DOCKETED	
Docket Number:	08-AFC-08A
<b>Project Title:</b>	Hydrogen Energy Center Application for Certification Amendment
TN #:	201993
<b>Document Title:</b>	Association of Irritated Residents Status Report
<b>Description:</b>	update on Wasco coal facility expansion
Filer:	Tom Frantz
Organization:	Association of Irritated Residents
Submitter Role:	Intervenor
Submission Date:	4/9/2014 3:09:44 PM
Docketed Date:	4/9/2014

Re: 08-AFC-8A

AIR status report

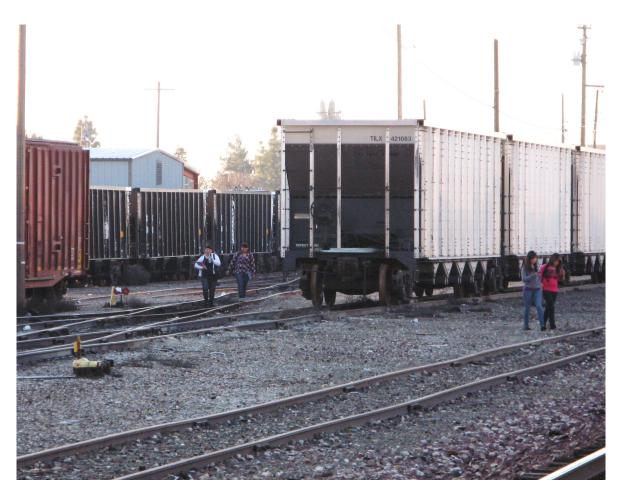
- Noise at night causing windows to be closed and lack of sleep
- Periodic blockage of the Poso St railroad crossing
- Alternative 6<sup>th</sup> street railroad crossing needs repairs and has no sidewalk or lighting
- Walking Children and adults continually cross the railroad tracks near the Amtrak station to get to 7<sup>th</sup> street on their way to shopping and school. They have even been seen crawling under coal cars as they cross the tracks (see picture below).
- Dust on clothes hanging to dry.

This photo is of school kids from the farm labor camp crossing the tracks between empty coal cars on their way to school. It was taken in 2011. Here is a link to a video showing a similar scene: <u>http://youtu.be/h8O56gZXuD0</u>
